UNITED STATES PATENT AND TRADEMARK OFFICE

10/667,056

Office Action Summary	Application No. 10/667,056	Applicant(s) MCFERRAN, SEAN	
	Examiner Phillip Gray	Art Unit 3767

DETAILED ACTION

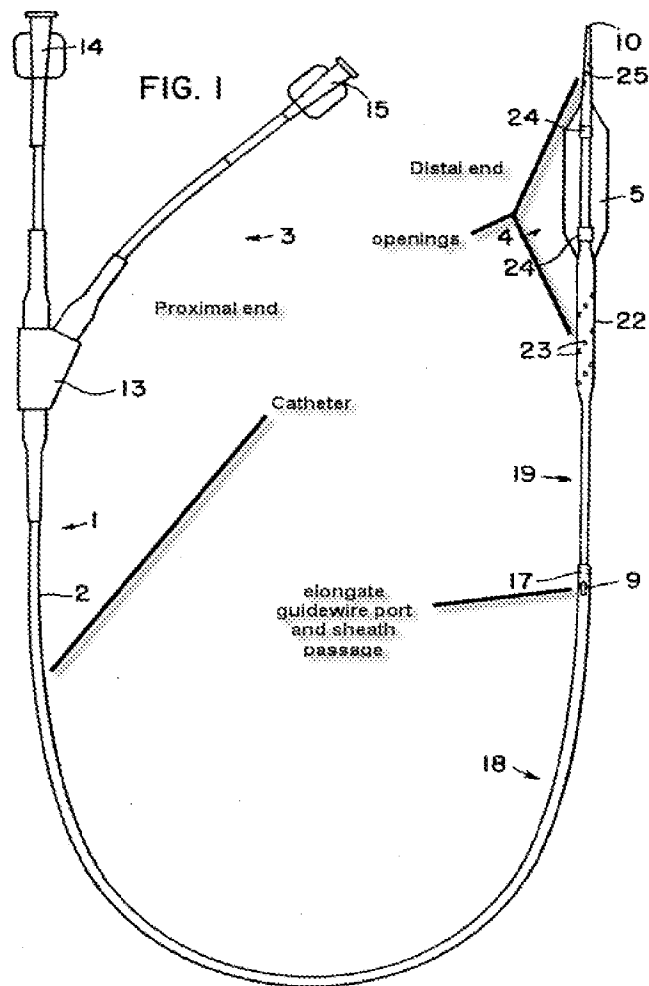
Further is it examiners position that both Pfenninger and Allman discloses "a slit extending at an angle such that the slit has a depth measured from the inner surface to the outer surface of the polymer sheath that is greater than the thickness of the wall of

the polymer sheath, wherein the slit is defined between a first edge of the polymer sheath and a second edge of the polymer sheath facing the first edge, wherein each of the first edge and the second edge extend from the outer surface to the inner surface of the polymer sheath, and wherein the first edge and the second edge are in contact with each other when no guidewire is extended through the passage". Both Pfenninger and Allman teach this as would any slit on an angle less than 90 degree to the outer surface (see Pfenninger figure 3 and Allman figure 4B or 4C).

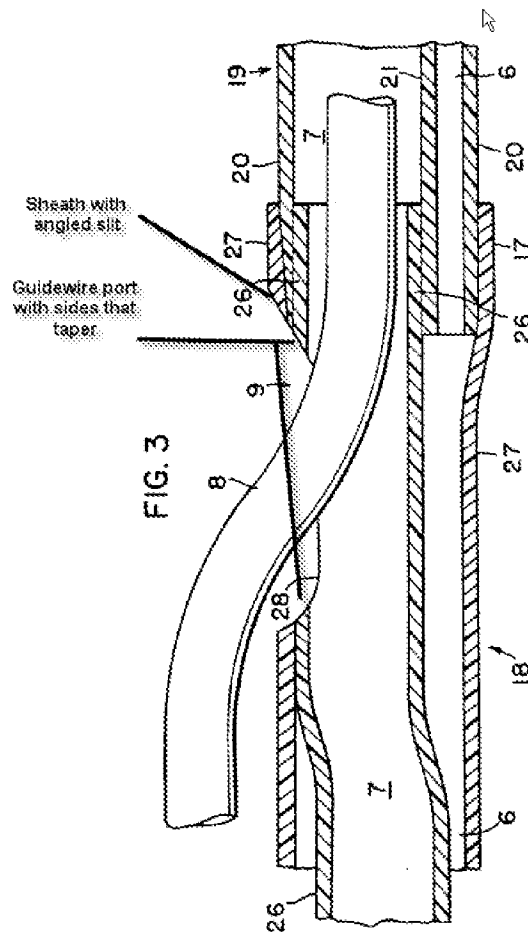
Pfenninger discloses a catheter (near 2) comprising an elongate shaft having a distal and proximal end fluidly connected to an opening (25/23) at the distal end of the elongate shaft, an elongate guidewire port (near 9), and a polymer sheet with a passage over the guidewire port (see marked up figure 1)

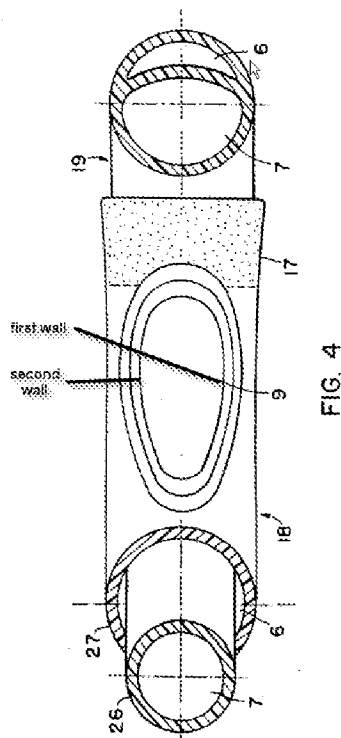
Further note the Sheath (27), angled slit see figure below, guidewire port (near 9 or 28) with tapered walls (see marked up figure 3 below).

Concerning claim 15-16, see near 27 in figure 3.

Concerning claim 23 see marked up figure 4 below. Concerning claim 24 note slit length is larger than port length. Concerning claim 25-26 note port near 28 tapered edges as in figures 3 and 4.
